SUBJECT: Initial Draft of Performance Specification Sheet MIL-PRF-19500/760B,
Project Number 5961-2026-072.

The initial draft of the subject document was generated to update the U2A case outline and to update it to the latest document format and various editorial changes to bring it into compliance with MIL-STD-961. Highlighting has been used for easy change recognition.

MIL-PRF-19500/760B
DRAFT
SUPERSEDING
MIL-PRF-19500/760A
w/AMENDMENT 5
25 August 2025

TRANSISTOR, FIELD EFFECT RADIATION HARDENED, N-CHANNEL, SILICON,
ENCAPSULATED (SURFACE MOUNT PACKAGE), TYPES 2N7579, 2N7581, 2N7583, AND 2N7585,
JANTXV, AND JANS

FIGURE 2. Physical dimensions, U2A surface mount.

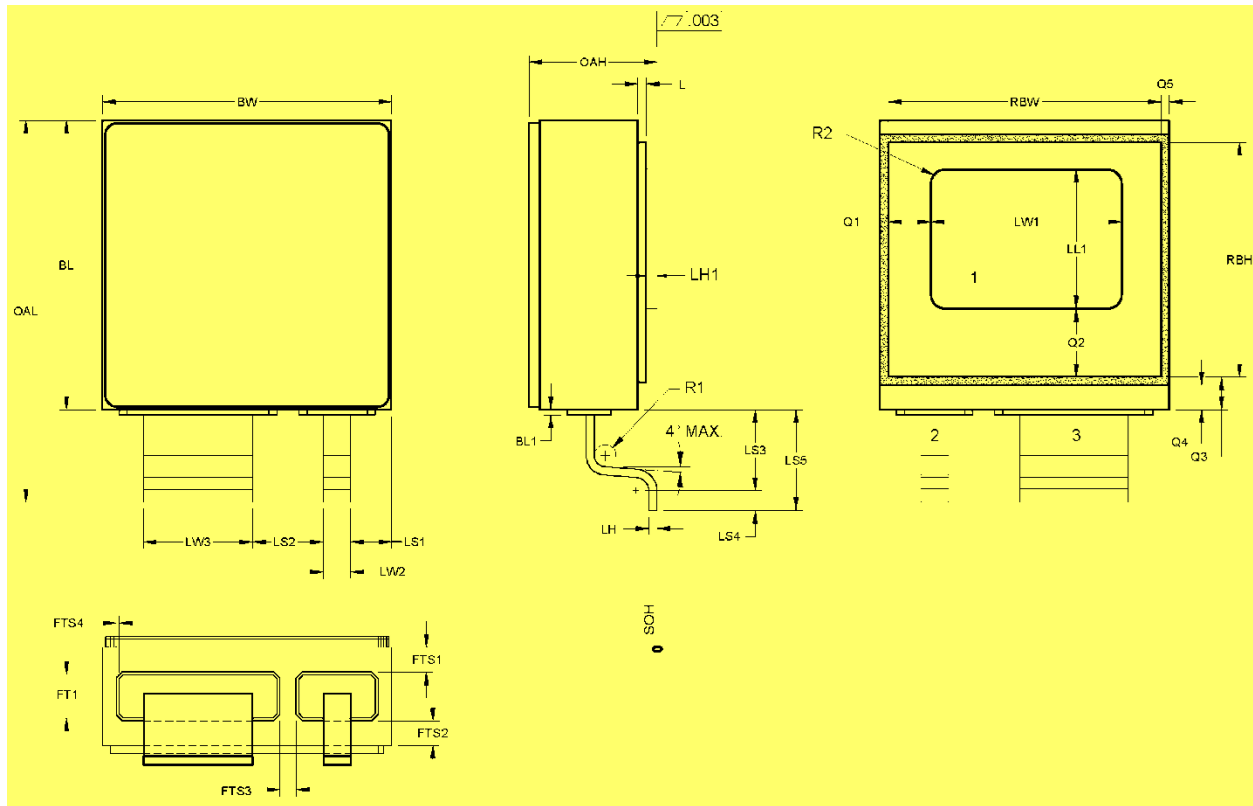
* 3.4 Interface and physical dimensions. Interface and physical dimensions shall be as specified in MIL-PRF-19500, and on figure 1 (TO-276AC) and figure 2 (U2A) herein.
